TOWN OF PALM BEACH

PZ&B Combination Staff Combination Memorandum: Architectural Commission and Town Council

SUBJECT: ARC-23-146 (ZON-23-119) 995 S OCEAN BLVD

MEETING: NOVEMBER 20, 2023 ARCOM

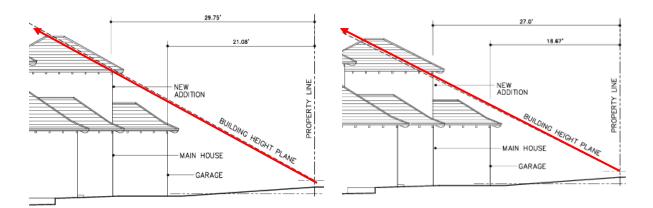
The applicant is seeking to add a second floor to the one-story garage. In order to do so, variances are required to further encroach on the front yard setback. The variance would be to (revest) reduce the front yard setback at the first floor varying from 18.67 to 21.08 where 35' is required (variance #1) and to reduce the front yard setback at the second floor varying from 27' where 35 is required (variance #2). The applicant has designed the second floor to be further setback from the street.

Both variances reflect the greater relief distance as the right of way is at an angle to the structure placement on the lot. The second floor addition will contain approximately 215 SF of enclosed space and be utilized as an art studio to be added above an existing one-story area.

Both the building height and the overall building height will be lower than the existing 2-story areas. The existing flat roof of the garage will be removed and a sloped roof with a lower eave line will replace it.
